**SUMMARY OF CITY COMMISSION ACTION ON
PETITION DB-18-17 SUB OAKS PRESERVE CLUSTER SUBDIVISION**

PROJECT NAME AND NUMBER: Oaks Preserve Cluster Subdivision, Petition DB-18-17 SUB.

RECOMMENDATION: Staff to City Commission – Approve the Design Plat for Oaks Preserve Cluster Subdivision, with conditions, authorizing the applicant to proceed to Construction Drawing Review.

EXHIBIT "A"

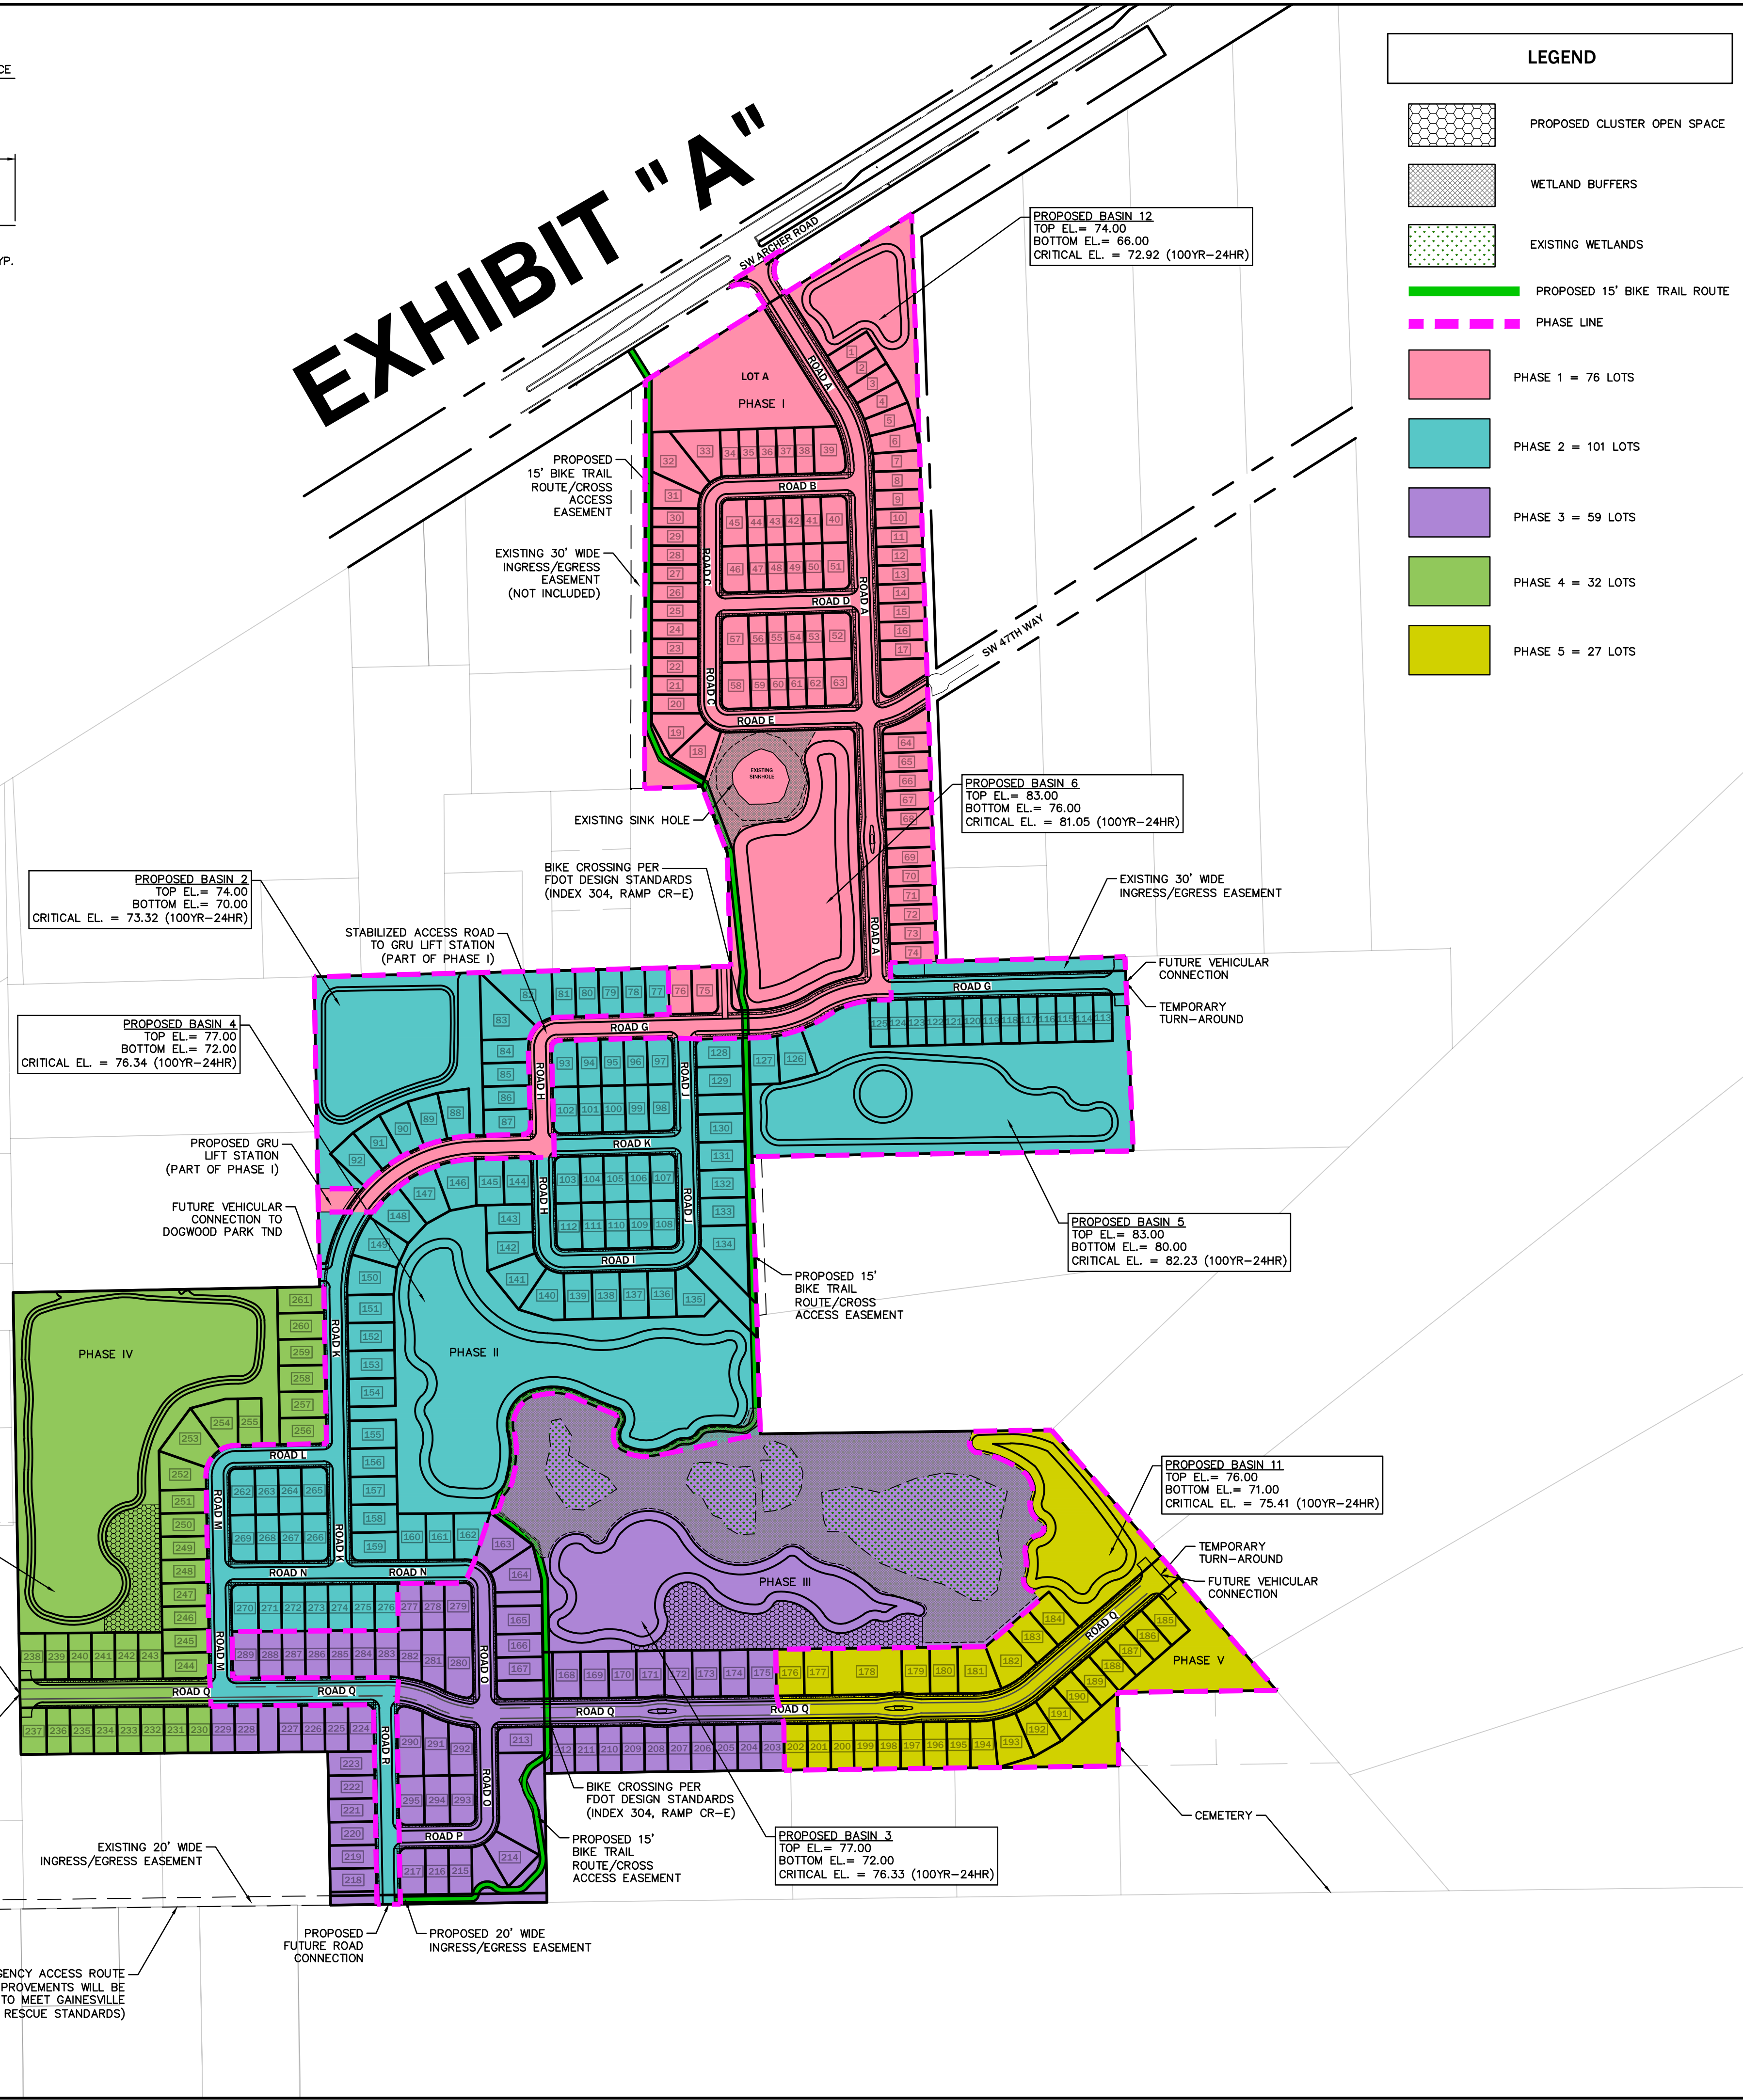
- 1. The north/south trail shall be reconfigured to run as an independent route and shall not be designed as a shared path within the proposed rights-of-way. The trail shall be designed as a 10-foot wide multi-use trail and shall be routed at the back of lots.**

- 2. The right of way corridor provided between lots 135 and 136 for access to tax parcels 06952-001-000 and 06952-003-000 shall be expanded to a minimum width of 50 feet.**

- 3. Prior to approval by the City Commission, the subdivision shall be designed to show a second or third phase with a third approved external connection to the closest officially paved roadway.**

The north/south trail is designed as a separate 15-foot wide route outside the main roadway network. Parts of the trail run to the rear of lots and around the environmentally sensitive area at the southern end of the development, as depicted in Exhibit "A" and "C". The trail crosses the road network at two locations. The trail will be constructed together with the specific phase in which it is located. Details of the trail will be reviewed and approved during Construction Drawing review and will receive final approval by the City

The 30-foot access corridor provided between lots 135 and 136 for access to tax parcels 06952-001-000 and 06952-003-000 has been increased to a minimum width of 50 feet and designated as right of way for future connectivity to adjacent properties to the east. The corridor will be designed to provide immediate access to the adjacent tax parcels.

The subdivision is planned to be implemented in three phases as depicted in Exhibit A. Approval of Phase II, or any phase after phase I, shall include construction of a 20-foot wide emergency access route within or along SW 57th Avenue. The route shall be designed to comply with or exceed the minimum Emergency Access Fire Rescue Route standards required by the Gainesville Fire Safety Department. Details of the route shall be included with Construction Drawing plans and shall require approval by the City Commission during review of Final Plat.

EXHIBIT "B"

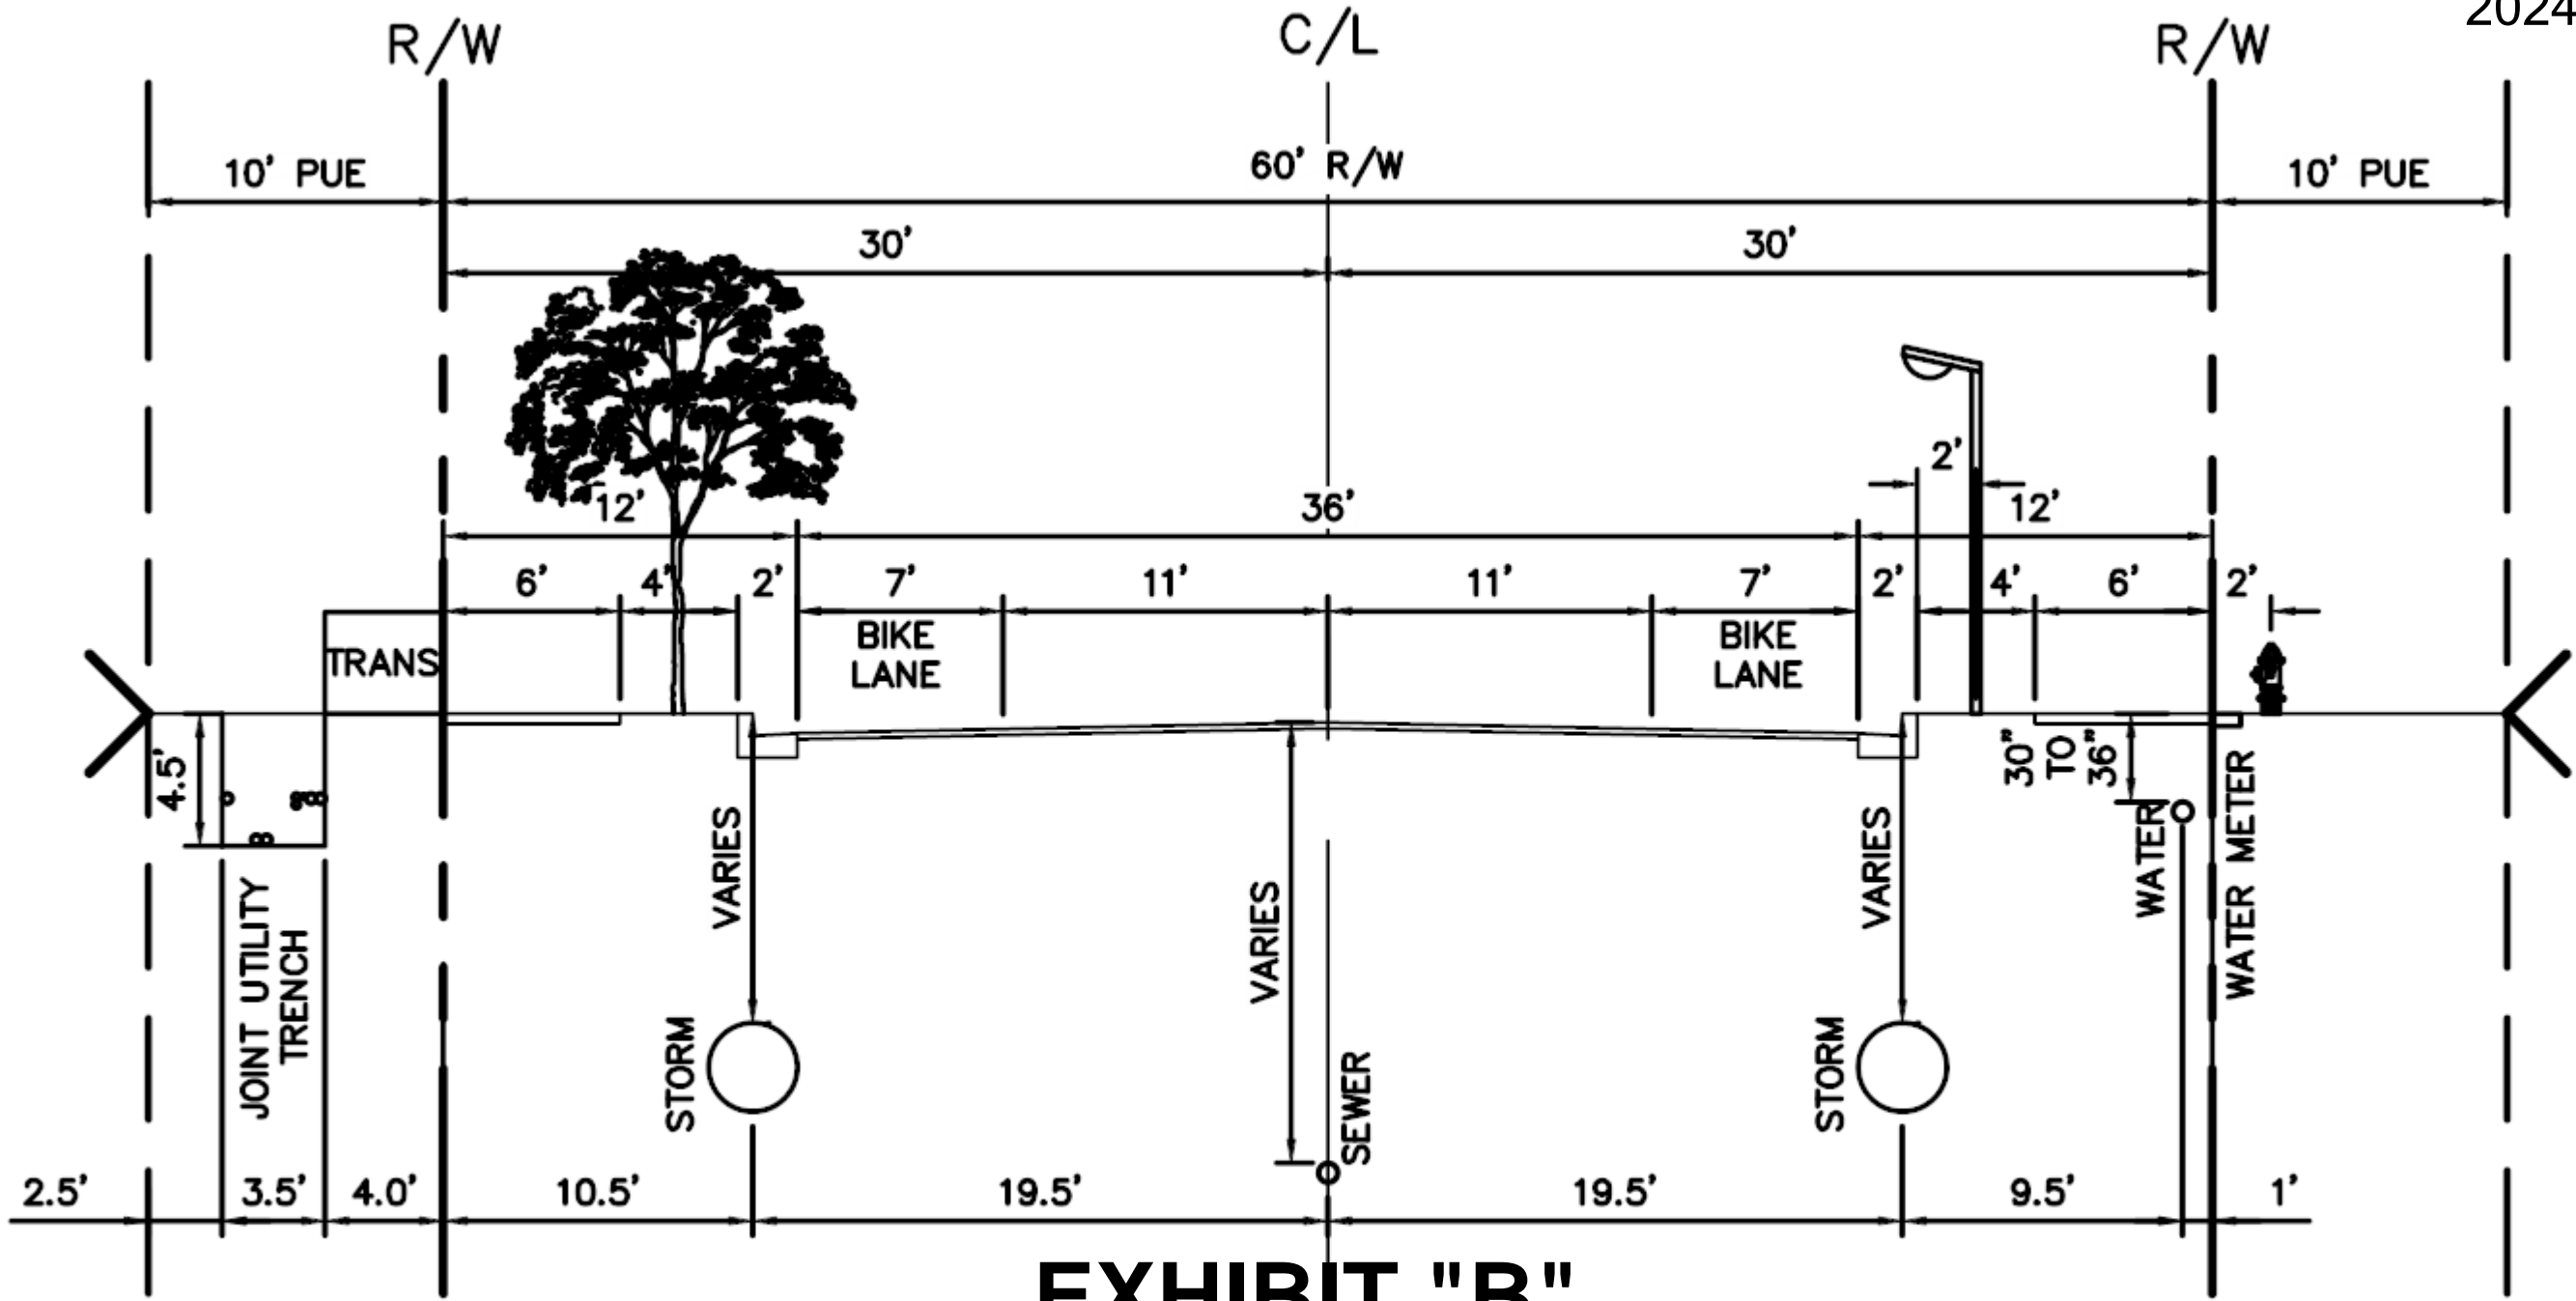
- 5. A 7-foot wide buffered bike lane shall be constructed on both sides of Road "Q"; the design shall be resubmitted to the City Commission for final approval.**

A new design for Road "Q" is submitted showing a 7-foot wide bike lane on both sides of the road. Both the east and west ends of the road have been designed to accommodate future connections without impacting proposed lots. Additional details are depicted in Exhibit "B".
